Interrogatory WCP-1

The United Illuminating Company
Docket 317

Trumbull Substation Project

**Trumbull Substation
Project**
**Town of Trumbull
Wetlands Map**
Trumbull, Connecticut

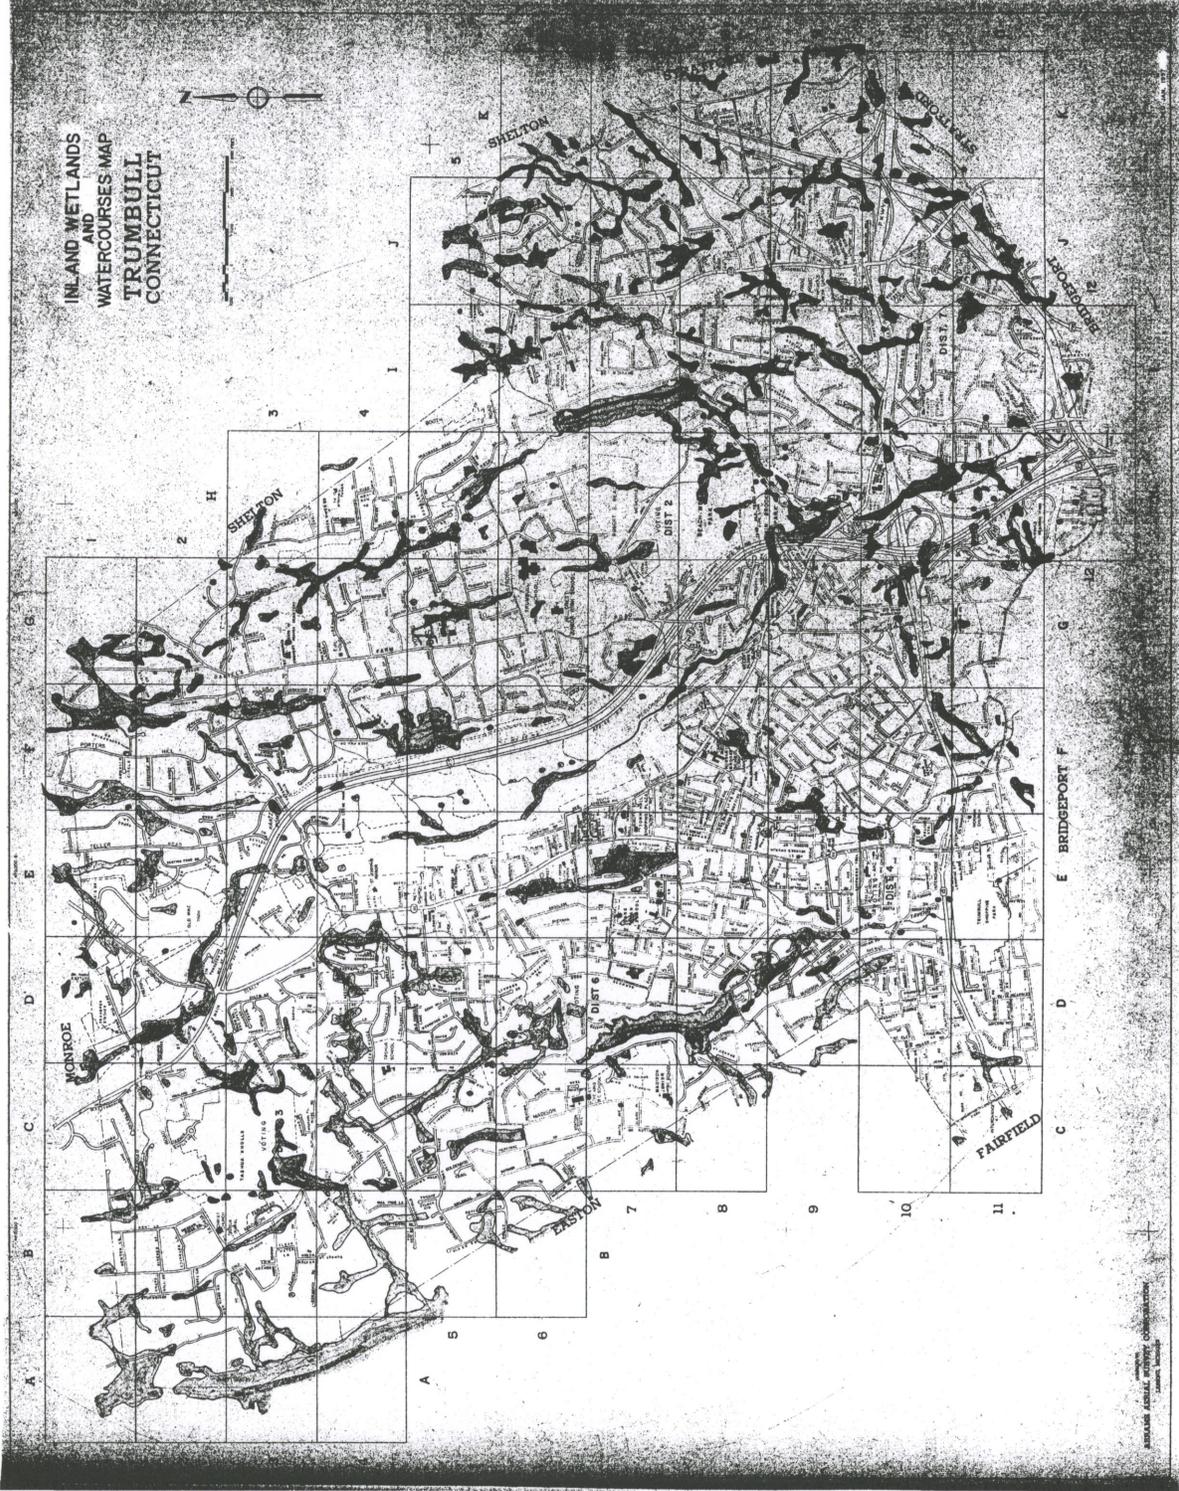
Q-WCP-3: Please provide all of the documentation upon which you reviewed and/or relied in making a determination or identification of wetlands or watercourses for all of the possible site locations.

A-WCP-3: UI reviewed the Inland Wetlands and Watercourses Map, Trumbull, Connecticut, (Revised January 1977) for all sites, provided as attachment WFC-3-1. UI's contractor, Black & Veatch reviewed the U.S. Fish and Wildlife Service National Inventory mapping for the preferred site, held an informal consultation with Trumbull wetlands officials (Inland Wetlands Commission) at the Town of Trumbull offices and had a wetlands specialist examine the preferred site.
